Conway Planning Commission
Staff Report

7:00pm • January 17, 2017 • 810 Parkway Avenue

FOX RIDGE ADDITION PRELIMINARY SUBDIVISION

**CONWAY CITY PLANNING DEPARTMENT REVIEW
FOX RIDGE ADDITION PRELIMINARY PLAT
SUBMITTED BY: MIKE ELROD**

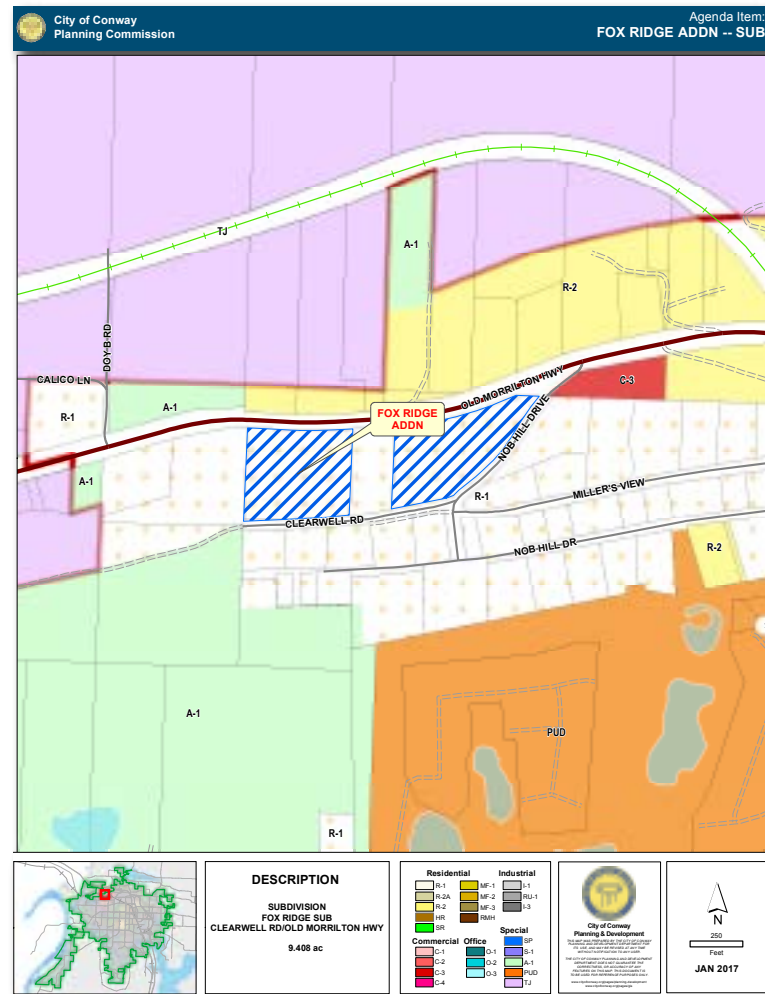
- STREET DESIGN REQUIREMENTS**
10. The rights-of-way of all streets must conform to the Master Street Plan and the requirements of Table 1, Street Classification & Design Standards, City of Conway in the Subdivision Ordinance. **The required Right of Way is 40' as recommended by the Street Department. A variance has been requested for a reduced Right of Way of 20'. The Planning Commission must approve this variance, or this condition must be corrected.**

11. The width of all streets must conform to the Master Street Plan and the requirements of Table 1, Street Classification & Design Standards, City of Conway in the Subdivision Ordinance. **The minimum Street Width for a Residential Street is 27'. A variance request for a street width of 20' has been received. The Planning Commission must approve this variance, or this condition must be corrected.**

16. State Fire Code 503.0.5 states that dead-end fire apparatus access roads in excess of 150 feet in length shall be provided with an approved area for turning around fire apparatus. Anything other than the following cul-de-sac requirement must be approved by the Conway Fire Marshall. **A variance request has been received for a hammerhead built into the driveway of Lot 1 in lieu of a cul-de-sac. The Planning Commission must approve this variance, or this condition must be corrected.**

21. The minimum building setback (building line) shall be no less than 25 feet from the right-of-way of the front street, or as required by the Zoning Ordinance.
22. Double frontage lots other than corner lots fronting on two streets shall not be platted except under extreme circumstances, as may be approved by the Planning Commission. **Lots 1 thru 7 are plated as double frontage lots. The Planning Commission must approve this variance, or this condition must be corrected.**
23. Every lot must slope to a street or to a drainage easement.

Planning Commission approval is needed for items 10, 11, 16, 22 and 26. Staff recommends approval of the preliminary plat subject to the amended punch list.

**HAVEN HOUSE
 SITE PLAN**

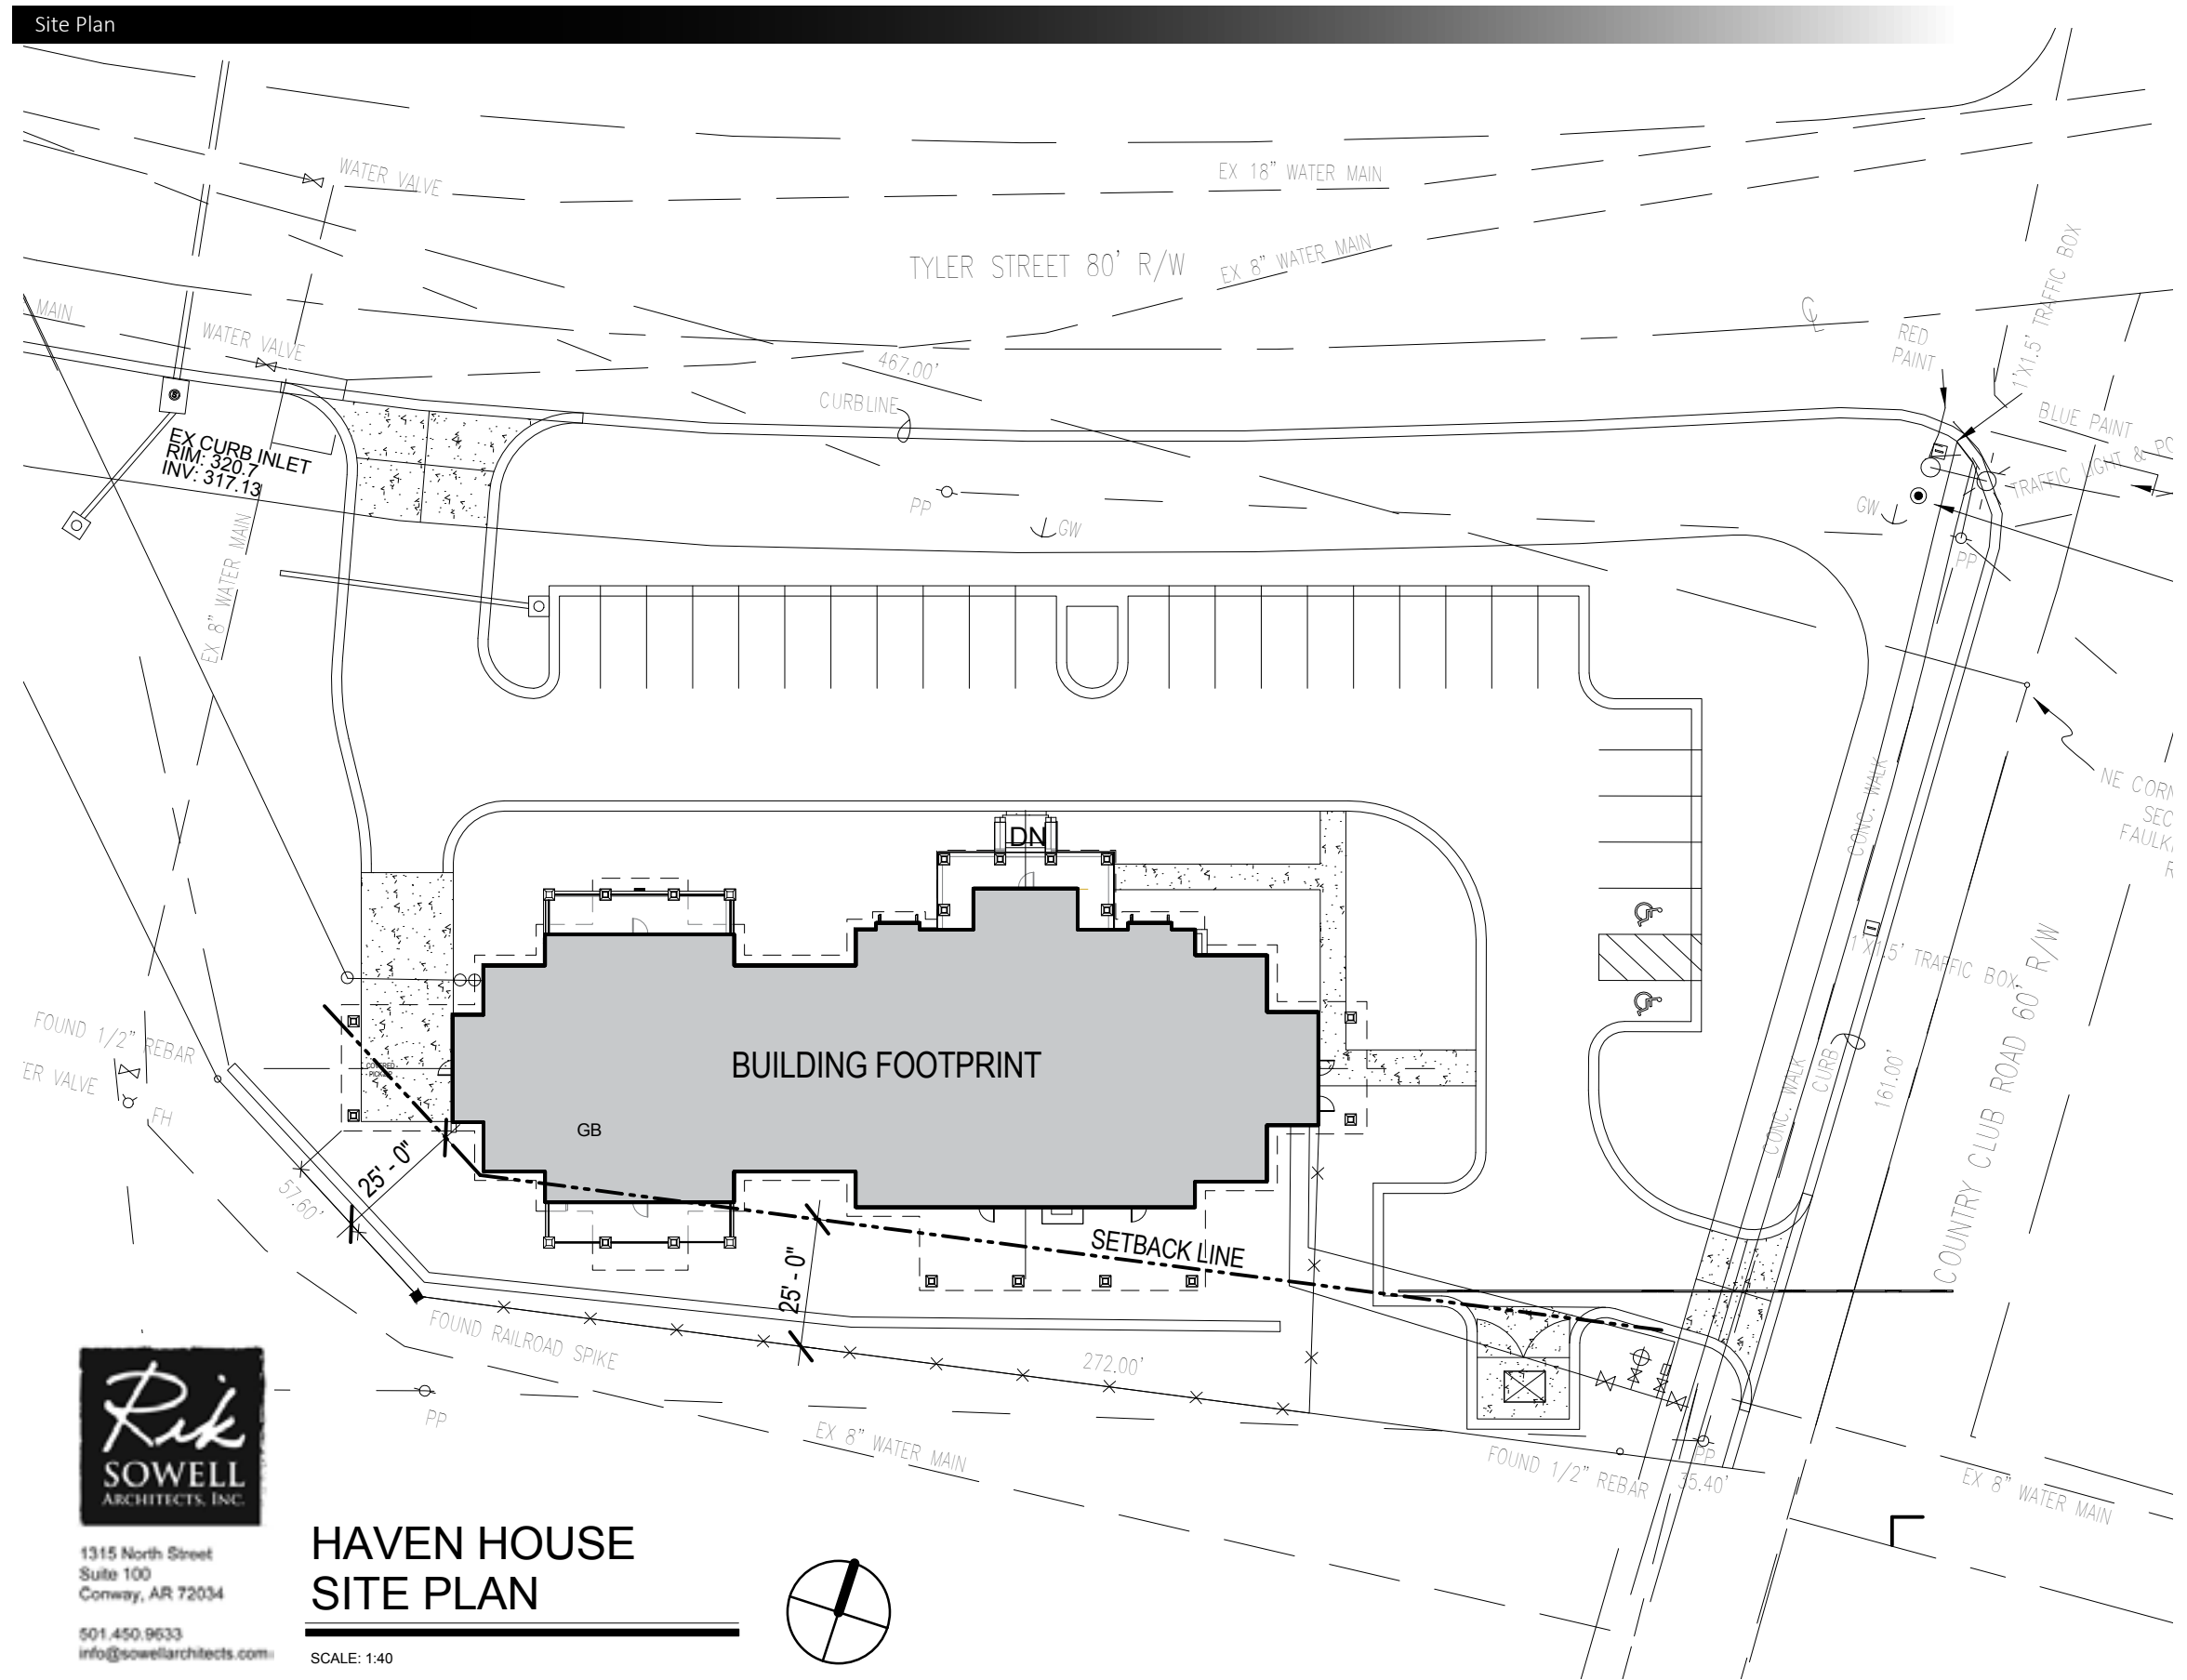
The applicant is requesting a zoning variance to allow smaller setbacks on the side and rear lot lines. The proposed project includes covered porches that extend into the S-1 zoning 25 feet required setback. The reduced setback areas about the Julia Lee Moore Elementary School property which has an existing fence and an open field with no playground structures or buildings nearby.

The applicant is also requesting a variance for a slightly reduced landscape buffer along the Tyler Street frontage. This reduction request is due to topography and site layout difficulties. The current standards require a 10 feet buffer, however the proposed layout shows a varying 8 to 10 foot buffer.

Zoning Ordinance Regulations. The current plan is out of compliance with regards to side and rear setbacks and landscape buffer along Tyler St:

SUGGESTED VARIANCE
 Due to topographical difficulty and the lack of any adjacent structures;
 1. Setbacks on the side (southwest) and rear (south) shall be reduced from the required 25 feet to allow the structure and porches to encroach up to 16 feet into the required setback.
 2. Landscaping buffer along Tyler Street may be reduced from the required 10 feet to 7 feet as shown on proposed site plan.
